STAGE 1 ROAD SAFETY AUDIT

Pedestrian Facilities
Land at South Side
Steeple Aston, Oxfordshire

Prepared for: Rectory Homes
Ref: TR8171225/GT/018
Issue 1: 5 November 2019

Figure 1

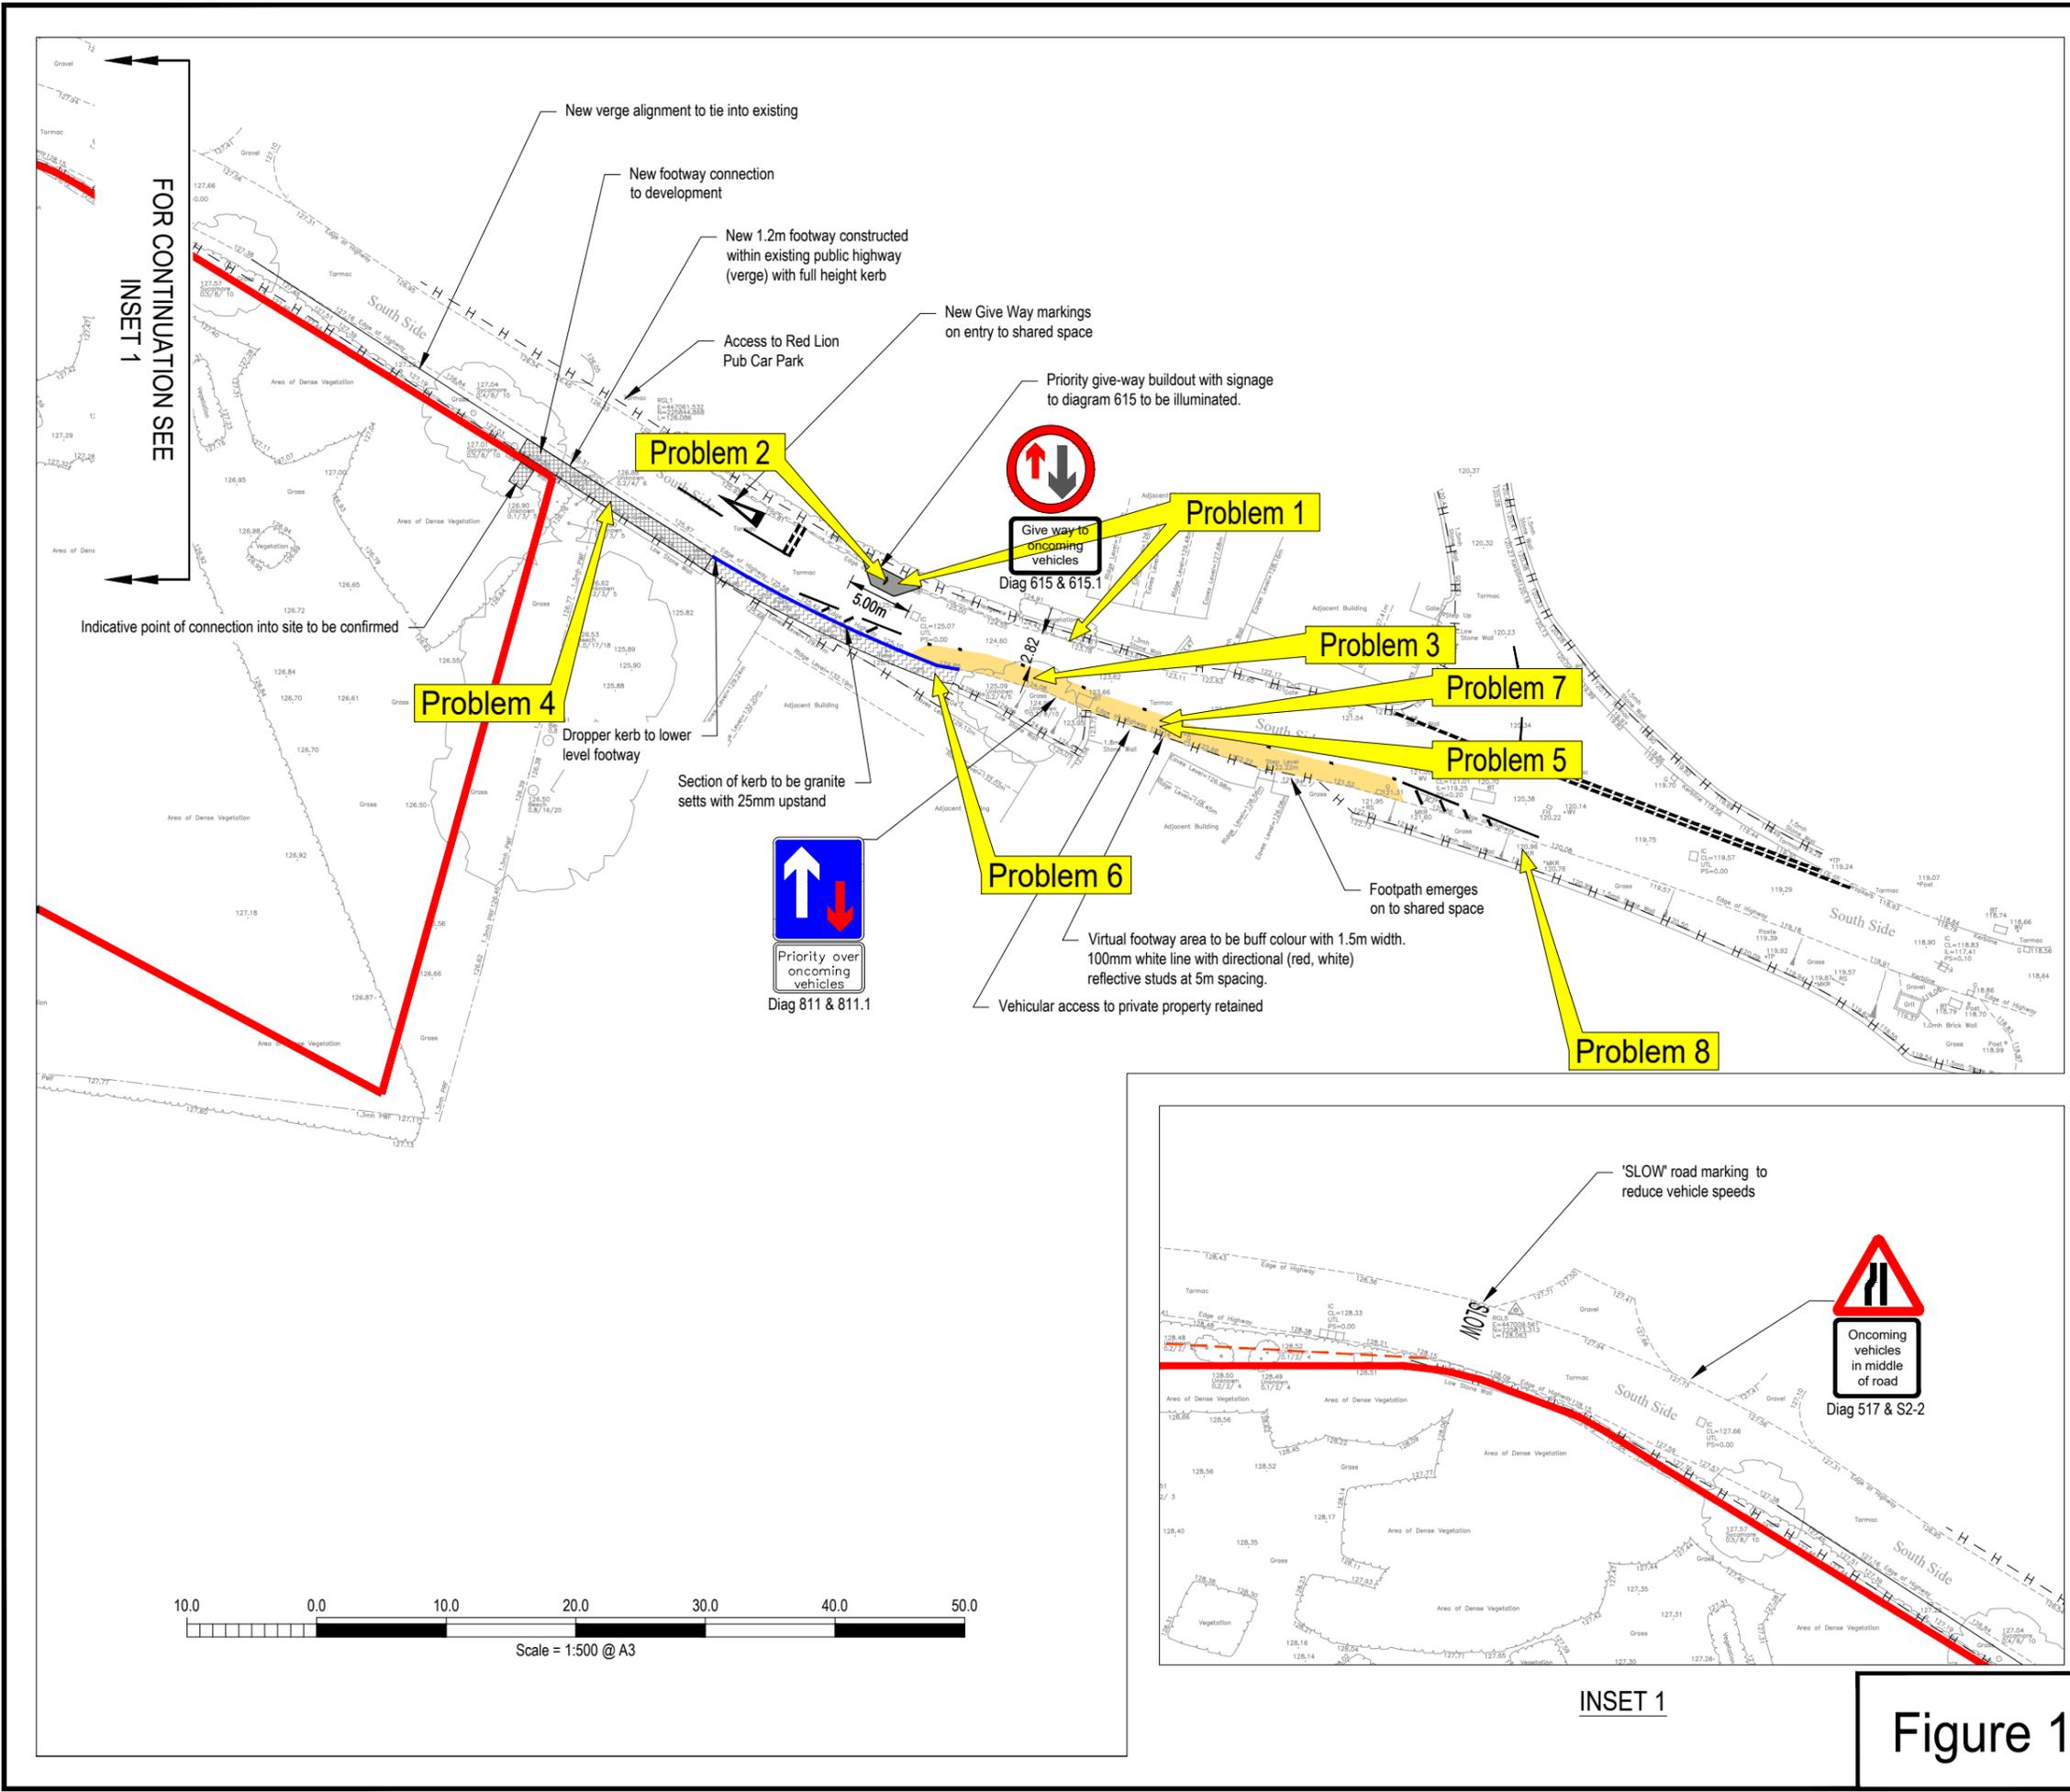
- 1.17 All safety problems and recommendations are referenced to the layout drawing at Figure 1.

The existing nearside hedgerow on the eastbound approach to the proposed priority give way line and east of the proposed build-out was noted to partially obstruct forward visibility. This may result in drivers passing the give way line whilst having insufficient sight of on-coming vehicles travelling east to west along South Side. As a result, vehicles travelling west to east may be unable to sufficiently clear the proposed kerbed build-out, giving rise to a risk of either vehicle / vehicle head-on collisions or collisions with the build-out, both with possible personal injury occurring.

There is a concern that the proposed assembly comprising signs conforming to diag 615 and 615.1 will obstruct forward visibility for drivers of larger vehicles or SUVs travelling west to east who are likely to be seated in a more elevated position. This may result in drivers passing the give way line whilst having insufficient sight of on-coming vehicles travelling east to west along South Side giving rise to a risk of vehicle / vehicle head-on collisions with possible personal injury occurring.

The introduction of the virtual footway will locally reduce the carriageway width to 2.82 metres. Whilst the Audit Team accepts that the virtual footway is designed to be over-runable, there is the potential that some drivers travelling west to east may be reluctant to use this additional width when attempting to overtake a cyclist or will be unable to use it if it is occupied by a pedestrian. There is a similar concern in respect of cyclists travelling in the opposite direction. This gives rise to a risk of collisions with possible personal injury occurring. [Note: Local Transport Note 1/07 (Traffic Calming) recommends that *'Total widths through narrowings of between 2.75 and 3.25 metres should be avoided if no cycle bypass is provided'*].

A mix of over-runnable and kerbed footway will be provided between the development site and the virtual footway. There is a concern that larger vehicles passing similarly sized vehicles waiting at the priority give way will have to use part of the kerbed footway during this manoeuvre. This may lead to loss of control incidents and / or a risk of injury being caused to vehicle occupants.

Existing vegetation currently overhangs the route of the proposed virtual footway. This will cause obstruction leading to pedestrians having to step into the carriageway giving rise to a risk of vehicle / pedestrian collisions with possible personal injury occurring.

Pedestrians with a visual impairment are given no indication of where the over-runnable footway ends, and the virtual footway commences. Furthermore, all pedestrians must transfer to and from both footways via a dropped kerb with a 25mm upstand. There is a concern that an absence of demarcation at the end of the over-runnable footway and the kerb upstand may both give rise to trips or falls with possible personal injury occurring.

In order to demarcate the edge of the virtual footway it is proposed that directional red and white studs are installed. Conventionally white studs are used to indicate a traffic lane or centre of carriageway marking. Hence, their use in this instance may be confusing to approaching drivers giving rise to a risk of pedestrian / vehicle collisions with possible personal injury occurring.

Conventionally red studs are installed to indicate a line which should not be crossed and thus drivers may be reluctant to use the virtual footway when passing other road users travelling in the same direction. This may lead to side swipe collisions with possible personal injury occurring.

The virtual footway terminates at its eastern end such that pedestrians are left exposed with no defined onward route using other existing facilities. The opposite, east to west route is also an issue since there is no defined route guiding pedestrians from existing facilities to the virtual footway. This may lead to confusion and a risk of pedestrian / vehicle collisions with consequent personal injury occurring.

It is recommended that the existing hedgerow is trimmed back along its length at least as far as the highway boundary, if this can be easily defined. Future growth shall be monitored and trimmed as required as part of an on-going maintenance programme. It is also recommended that the build-out is not kerbed but is instead constructed to be fully or part over-runnable thereby providing larger vehicles with additional carriageway width to take avoidance action if required. The proposed sign assembly to be installed within this build-out should be relocated as a result, whilst ensuring that sufficient horizontal clearance is provided.

It is recommended that the sign assembly is relocated such that forward visibility is not compromised, whilst ensuring that sufficient horizontal clearance is achieved.

It is recommended that the width of carriageway adjacent to the virtual footway is either increased to a minimum of 3.25 metres (recognising that the width of the adjacent footway may need to undergo a commensurate reduction in width) or the carriageway width is reduced to be no wider than 2.75 metres, thereby discouraging drivers from attempting to pass a cyclist.

It is recommended that the full length of footway between the development site and the virtual footway is constructed to be over-runnable.

It is recommended that overhanging vegetation is extensively trimmed back to ensure that the full width of the virtual footway can be used by pedestrians travelling in either direction.

It is recommended that a short length of dropped kerb with an upstand not exceeding 6mm is provided at the eastern end of the over-runnable footway, where pedestrians must transfer to and from the virtual footway and some form of demarcation indicating the end of the over-runnable footway is also provided.

It is recommended that the edge of the virtual footway is clearly defined which may be through the use of an alternative stud colour that avoids the potential for confusion with its conventional use, or by other means.

It is recommended that appropriate facilities are included as part of these works to allow all pedestrians to transfer between the virtual footway and existing facilities.
